Conservation comments	
Reference number	20/115160
Address	Sydenham Hill Estate – Mais House
Proposal	Demolition of existing buildings at Mais House and Otto Close garages, SE26, and redevelopment to provide a part four, six and seven storey building and a part two and three storey terrace building providing a total of 110 residential units (use class C3), community room and estate office; together with alterations to the existing ball court; associated works to vehicular and pedestrian access from Sydenham Hill, Lammas Green and Kirkdale; provision of car and cycle parking, refuse storage and landscaping including amenity space and play area.
Conservation Officer	Joanna Ecclestone
Date	28.01.2020

Scale of northern terrace of Lammas Green, close to Otto Place. No. 23 on right

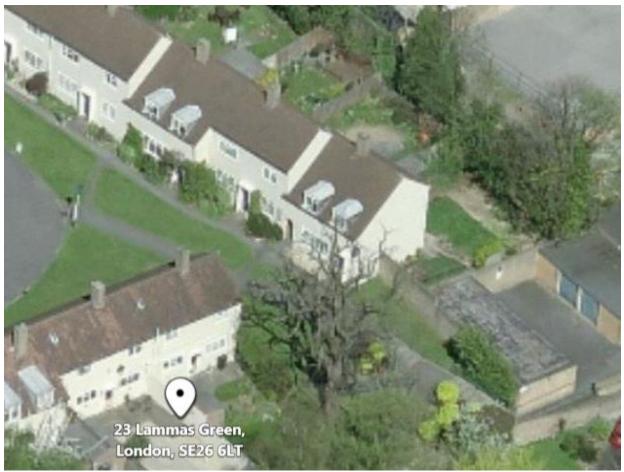
Demolition of retaining wall adj 23 Lammas Green –needs to be included on Demolition Plan. Need assessment of its significance, and details of extent of demolition to assess whether its removal would affect the special interest of the LB and therefore whether LBC is required. What will the replacement treatment be?

Wall proposed for demoliiton to right of 23 Lammas Green. #which section of wall is to be removed?
